NEW NUCLEAR SOURCE AT THE DUKOVANY SITE

REVIEW OF NATURA IMPACT ASSESSMENT

BACKGROUND PAPER FOR E.I.A. EXPERT REPORT
Under Act No. 100/2001 Sb., as amended by Act No. 326/2017 Coll.

Jihlava, May 2019

Delimitation of sectors under review

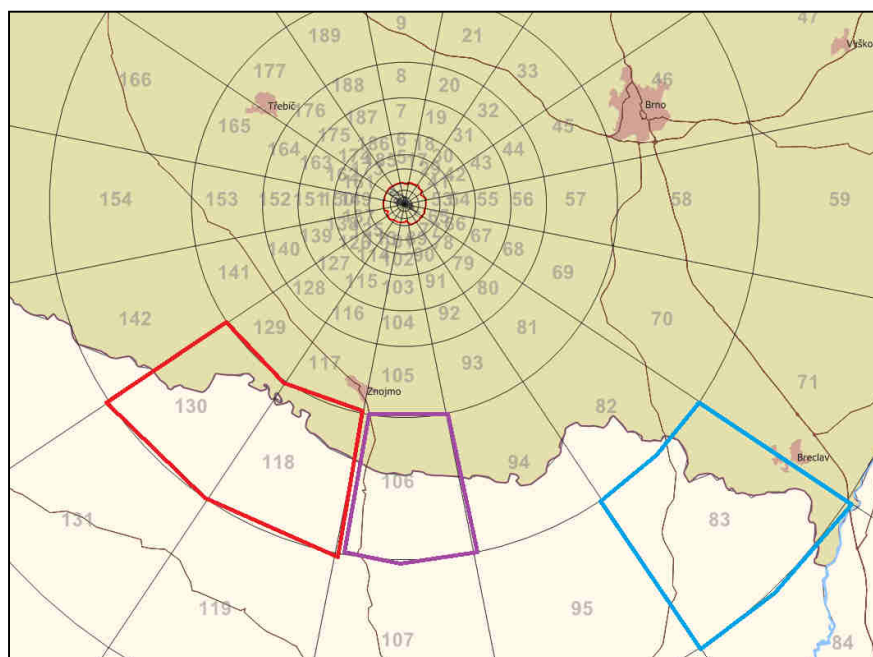
Individual areas of interest for calculating impacts on biosphere are shown at the figure below. Sectors 130 and 118 cover the area of National Park Podyjí, the sector 106 represents the area with strongest impacts on biota from atmospheric effluents and the sector 83 represents the area with strongest impacts on biota from effluents to hydrosphere, all in the territory of Austria.

Sectors 130 and 118 cover the area of National Park Podyjí, the sector 106 represents the area with strongest impacts on biota from atmospheric effluents and the sector 83 represents the area with strongest impacts on biota from effluents to hydrosphere, all in the territory of Austria

The reviewer holds the view based on the information presented above that specially protected area and sites of Natura 2000 system including their protection subjects cannot be adversely affect by the outputs, the explanation can be accepted as exhaustive.
